R. Chinn – 02/28/17

Red Hill Investigation

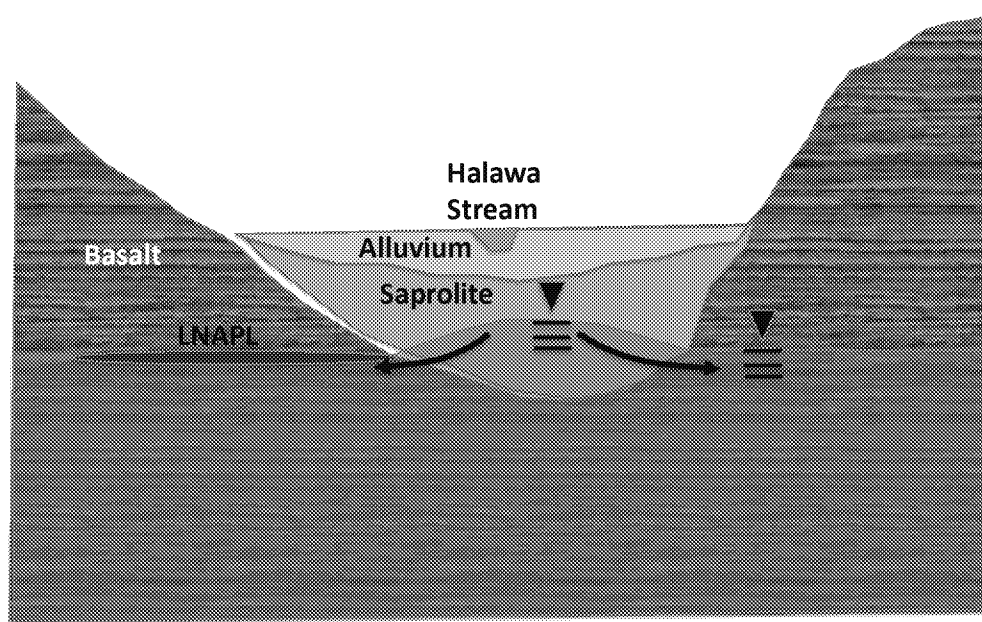
- **Well Location 1:** Propose targeting the center of the saprolite in the S. Halawa Valley makai of the Correctional Facility. Used in conjunction with the Halawa Deep Well, this well should be able to provide information about how the depth of saprolite varies with respect to distance toward Pearl Harbor. Groundwater elevations would be useful in constructing the groundwater model. My hypothesis is that GW at this location is lower than both at the Deep Well and at Red Hill – though the Deep Well may not provide representative elevations since it's screened so differently from all other wells. [Note that the well could be installed at the north end of the Correctional Facility parking lot.]

- **Well Location 2:** Propose targeting the center of the Quarry spur between North and South Halawa valleys. My hypothesis is that the groundwater elevation here will be marginally higher than found at Location 1 and the Deep Well. If this turns out to be the case, the groundwater flow direction will become clear when modeled. [Note that while this is in the center of the Quarry's operations, there is a large clearing that could be used for drilling purposes.]

- **Well Location 3:** Propose targeting the center of the N. Halawa valley to evaluate the depth of saprolite. Past literature suggests that the N. Halawa Valley is older than S. Halawa Valley, so the depth of saprolite may be greater...though it's unclear why the valley is so narrow here. If the saprolite extends well into groundwater, it represents a barrier to contaminant migration. While I agree that relying on this barrier as a line of defense against contaminant migration to Halawa Shaft is far less than ideal (i.e. it's way too close for comfort), the extent of saprolite is necessary for the purposes of the model. I hypothesize that the groundwater elevation here is marginally lower than found at the Quarry spur, though highly influenced by Halawa Shaft. [Note that there is an access road along the south side of H3 with a turnout. This could be used as the drilling location.]

- **Removal of RHMW11 and RHMW12:** Based on a review of the proposed locations, it seems that the lithology in center of S. Halawa valley is adequately described by the Deep Well. RHMW11 is unlikely to show saprolite extending to the groundwater table, as it's probably too close to Red Hill. Likewise, RHMW12 is also unlikely to show saprolite extending to the groundwater table, as it's probably too close to the Quarry spur. Of course there is some marginal benefit to these wells, but I'd rather see the money spent elsewhere.

- Need to ensure that the water level referred to is that in the basalt. The low permeability of the alluvium/saprolite will result in elevated water levels in these zones that may be continuous down to the permeable basalt. See Rotzoll's modeled GW elevations. Also, this well would not be optimally located to intercept contamination since it would flow around the valley if there is flow from the Moanalua Aquifer to the Pearl Harbor Aquifer.

- **Global Point –** Wells will be single point information that are not necessarily be able to extend up or down valley to understand how the geology found in the borehole will affect LNAPL and dissolved, and groundwater flow. Need to characterize water level and the structures in this region over a fairly broad area to understand groundwater flow.

- **Global Point** – Wells will be single point information that are not necessarily be able to extend up or down valley to understand how the geology found in the borehole will affect LNAPL and dissolved, and groundwater flow. Need to characterize water level and the structures in this region over a fairly broad area to understand groundwater flow.
- **Ground Truth** – wells could be used as ground truth other techniques of evaluating the sub-surface.
- **Groundwater Flow** – using available data it is incorrect to assume that the groundwater flow direction is parallel to alignment of the tanks. Taken at face value, using available TOC elevations the gradient is either flat down to RHMW01 or very slightly toward RHMW04.
